Report to the Chairman, Subcommittee on Europe and the Middle East, Committee on Foreign Affairs, House of Representatives

January 1987

# FOREIGN ASSISTANCE

## Analysis of Cost Estimates for Israel's Lavi Aircraft

**Figure 1: Future Value of Lavi Cash Flow Estimates** (Compounded at 6 Percent)

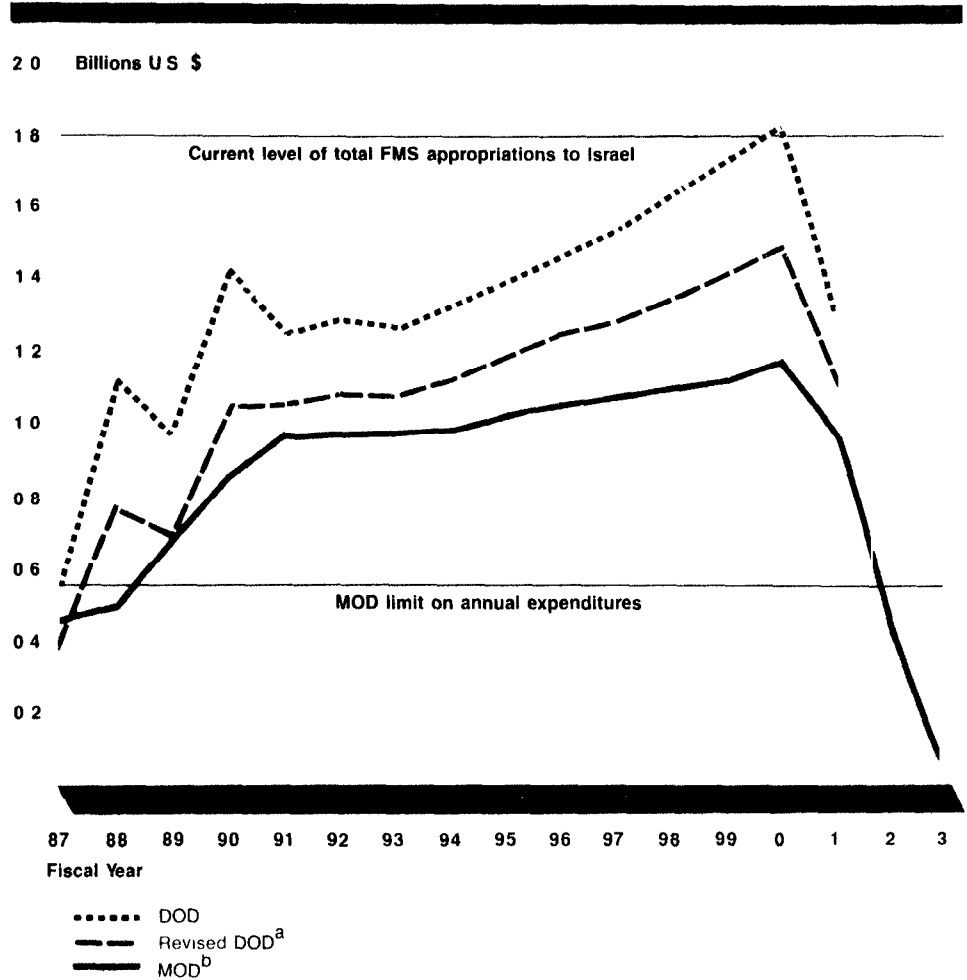
Although DOD's and Israel's estimates vary substantially, both project substantial growth in yearly cash requirements—that is, the amounts required to meet Israel's planned production. We estimate annual outlays will exceed \$1 billion by 1990 and exceed \$1.4 billion by the year 2000.

Regardless of which estimate one uses, projected annual outlays quickly exceed this spending cap. In fact, as production progresses, annual outlays begin to consume most of the currently authorized \$1.8 billion of U.S. military assistance. Figure 1 was based on cash flow estimates provided by DOD and Israel and inflated at the rate of 6 percent. (The gross national product deflator, which DOD uses to estimate weapon systems
